## Putting the Howarth & Jacobson Hydrogen Paper in Context:

### *Decarbonization and the Potential Greenhouse Gas Emissions Performance of “Blue” Hydrogen*

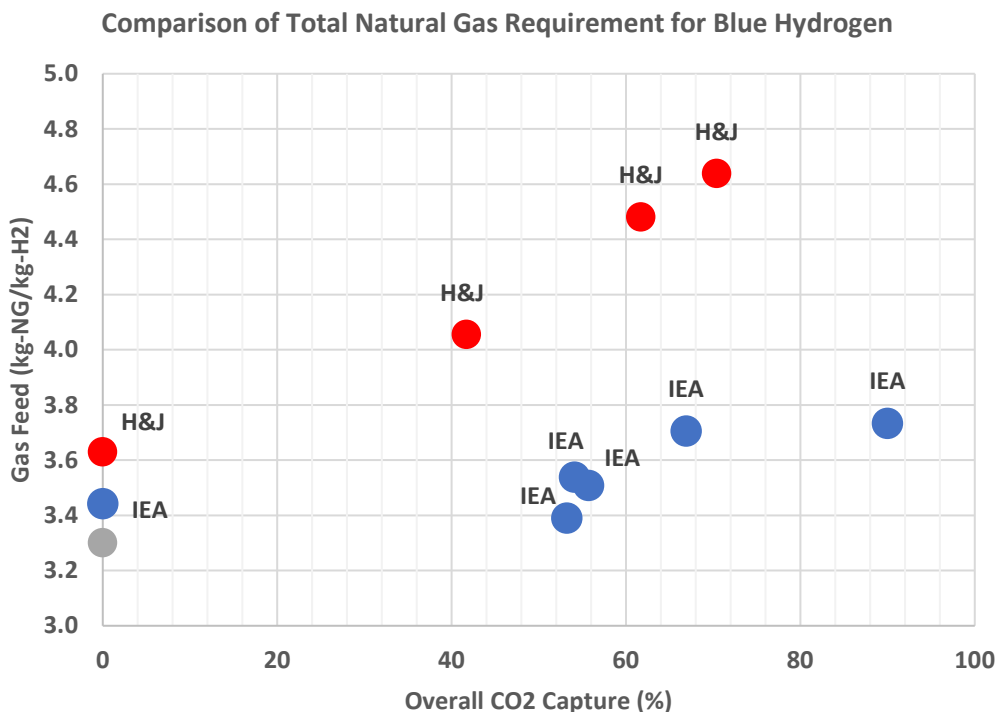
- The energy assumed by H&J to operate carbon capture is too high. To capture CO2 from process and flue gas H&J assumes an energy penalty significantly higher than standard estimates. As a result, the authors overstate the amount of fuel needed for carbon capture. In the figure below we have compared the total amount of natural gas required for each unit of hydrogen produced in the H&J paper with the results of [detailed expert analysis](#) by IEA for a range of carbon capture levels and plant configurations. The H&J natural gas requirements are substantially higher than estimated by specialists in the field. As a result, H&J overstate the amount of fuel needed for carbon capture, increasing both direct CO2 emissions and upstream methane emissions in the natural gas supply chain. Notably, H&J perform no sensitivity analyses on their assumption of how much energy is required for carbon capture or various reforming process configurations.

*Notes to figure: 1) H&J used simplified feed gas of 100% methane whereas IEA cases represent a more typical natural gas blend (still mostly methane but including some ethane and other gases), which increases H&J gas feed slightly versus IEA; 2) figures for H&J*

derived here using total gas feed in their Table 1 and 1.0 MJ (HHV) hydrogen production in each case (equivalent to 7.05 g hydrogen), except for the case at ~70% overall carbon capture which was derived by CATF from data in H&J, reflecting 7.11 g CH<sub>4</sub>/MJ-HHV-H<sub>2</sub>, but not presented by them directly in their Table 1; 3) Most IEA cases include a small net electricity export to grid, which is excluded here as H&J do not specify net electric balance in their analysis; including a credit for net electricity export would reduce the effective natural gas feed for most of the IEA cases slightly, especially the 0% carbon capture case; the grey dot in the figure represents this impact, assuming export power from the reforming plant site offsets 0.13 tonne of natural gas per MWh of electricity exported, following US DOE [studies](#) of new natural gas combined cycle plants.

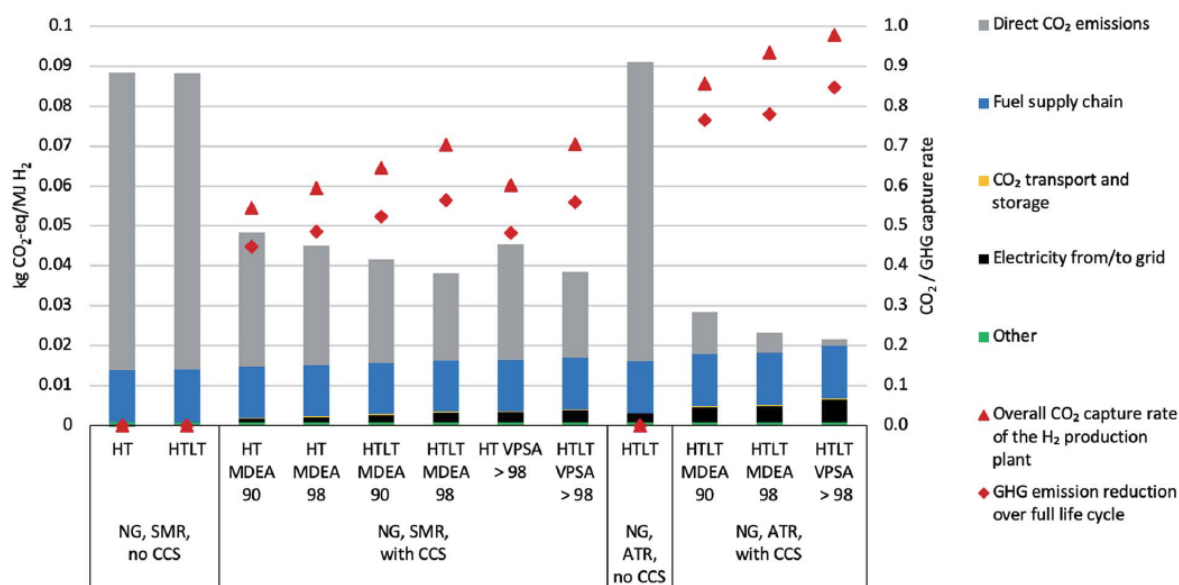
- **In total, the overall greenhouse gas emissions of blue hydrogen estimated by H&J are significantly higher than those of other researchers.** The ATR cases of Antonini et al utilize carbon capture ranging from 90%-98%+. These are summarized in the three rightmost columns in their figure below, with average GHG emission of around 23 gCO<sub>2</sub>e/MJ-LHV (where we have used LHV to denote that the values for hydrogen in Antonini et al are on a lower heating value basis). Of that total, on average around 13 gCO<sub>2</sub>e/MJ-LHV are due to the fuel supply chain. Those results are based on 100-year GWP. If we assume that all of the fuel supply chain emissions are methane (which will overstate methane impacts), and increase those to a 20-year GWP (multiplying by the ratio of GWPs 86/25 = 3.44), and also adjust to a gross (higher) heating value basis for hydrogen as used in H&J, the fuel supply chain emissions increase to around 38 gCO<sub>2</sub>e/MJ-HHV, and the average total hydrogen production emissions increase to about 46 gCO<sub>2</sub>e/MJ-HHV.

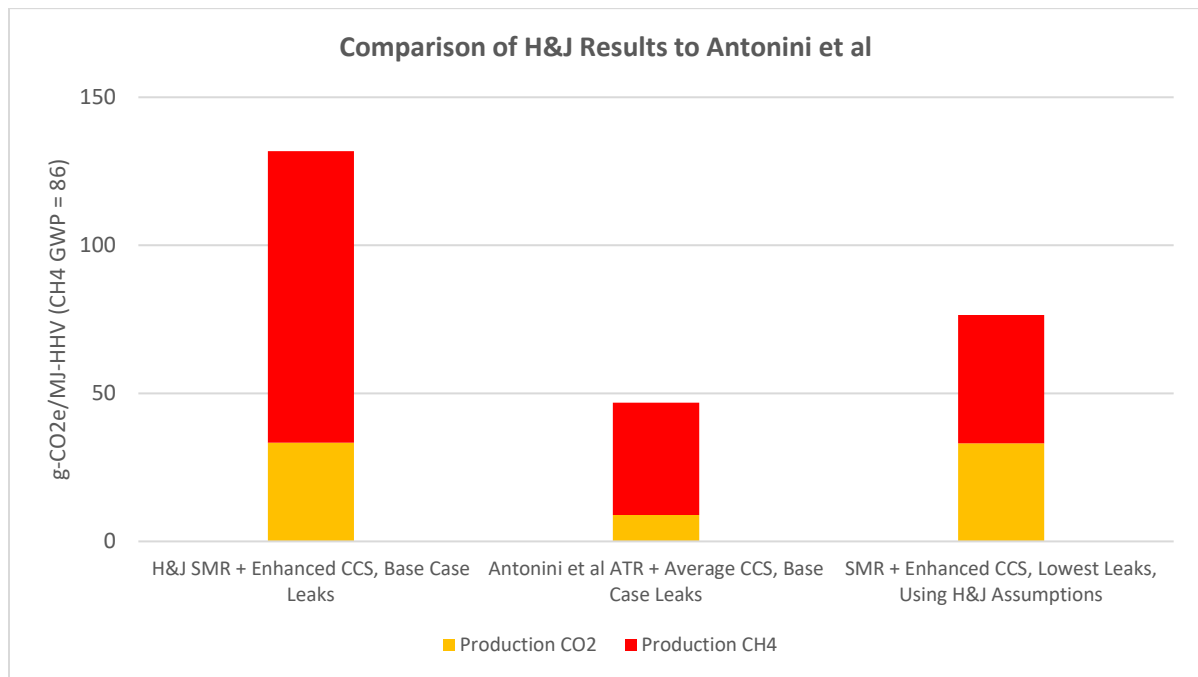
For comparison, the best H&J carbon capture case applies 90% CO<sub>2</sub> removal on both reformer process gas and reformer furnace flue gas, but no capture of CO<sub>2</sub> resulting from energy needed to drive the carbon capture process itself, resulting in around 70% carbon capture overall in their analysis. For clarity we label that H&J case “Enhanced CCS” here although much higher levels are possible. Combined with their base case methane leak rate assumption of 3.5%, this case results in about 132 gCO<sub>2</sub>e/MJ-HHV hydrogen, nearly a factor of 3 higher than Antonini et al. This comparison is summarized in the figure below.

Although H&J do not include a sensitivity case in their tabulated results that combines their Enhanced CCS with their most optimistic methane leak rate assumption of 1.54%, we have estimated that case using their tabulated information for other cases and included it in the comparison figure above. For this case in the H&J analysis there would be about 77 gCO<sub>2</sub>e/MJ-HHV. This is still more than 60% greater than the average Antonini et al results for ATR with carbon capture, after adjusting Antonini et al’s upstream methane emissions to reflect a 20-year GWP of 86.

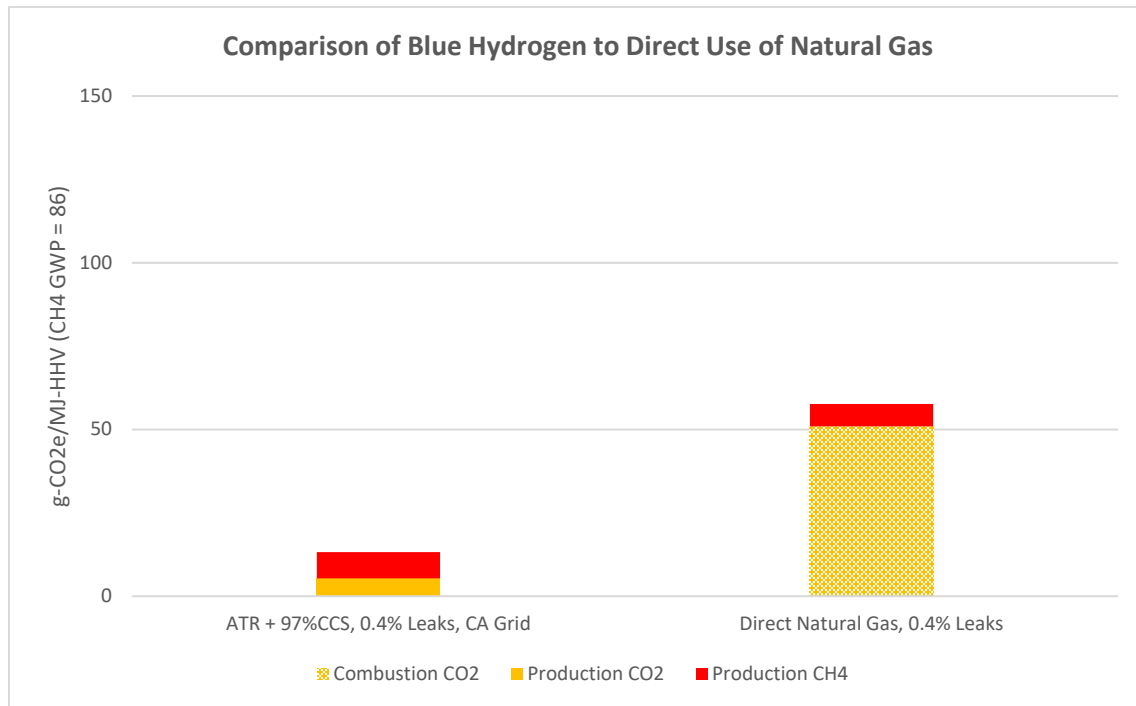
- Natural gas reforming with deep carbon capture, coupled with significant reductions in natural gas supply chain methane emissions, can produce a low-carbon hydrogen product.** [Our analysis](#) indicates that ATR with 97% carbon capture is technically feasible and available for early deployment and could result in greenhouse gas emissions of about 0.8 kg CO<sub>2</sub> per kg of hydrogen produced, equivalent to about 5.6 gCO<sub>2</sub>e/MJ-HHV, when using electricity with a carbon intensity of the California grid to power internal auxiliary loads. Because an ATR with this level of carbon capture would consume around 3.2 kg of natural gas for each kg of hydrogen produced, methane leaks of 0.4% in the fuel supply chain would increase the GHG emissions for the hydrogen by around 7.9 gCO<sub>2</sub>e/MJ-HHV more, using a 20-year methane GWP, resulting in a total of around 13 gCO<sub>2</sub>e/MJ-HHV (equivalent to 1.9 kgCO<sub>2</sub>e/kg-H<sub>2</sub>). Although not a full lifecycle analysis, this is approximately a 77% reduction in CO<sub>2</sub>e per unit of gross delivered fuel heat compared to burning natural gas directly, assuming the same reduction in methane

leaks for the direct natural gas pathway as we apply for the hydrogen pathway. Our results are summarized in the figure below.

Figure 3. Life cycle carbon intensity of hydrogen production

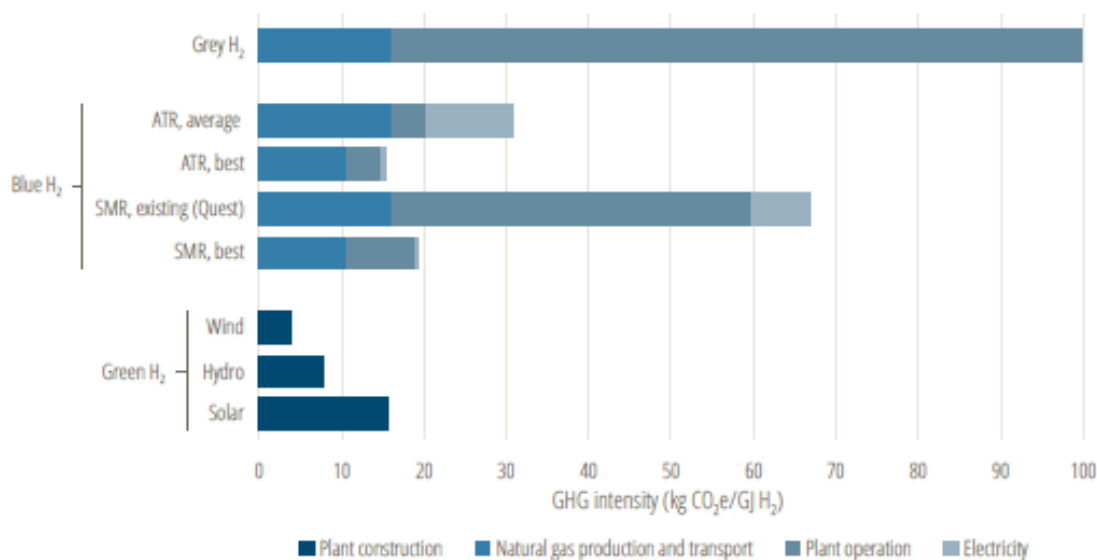
- NGO research in Canada aligns well with the Antonini et al results.** The Pembina Institute in Canada recently [published](#) a description of blue hydrogen production technologies and assessed their carbon emissions intensity. Similar to Antonini et al, upstream methane emissions were included as well as cases for solar, wind, and hydro power for electrolysis. The Pembina results are quite similar to the Antonini et al estimates. (When comparing figures note that 20 kg per GJ is the same as 0.02 kg per MJ).
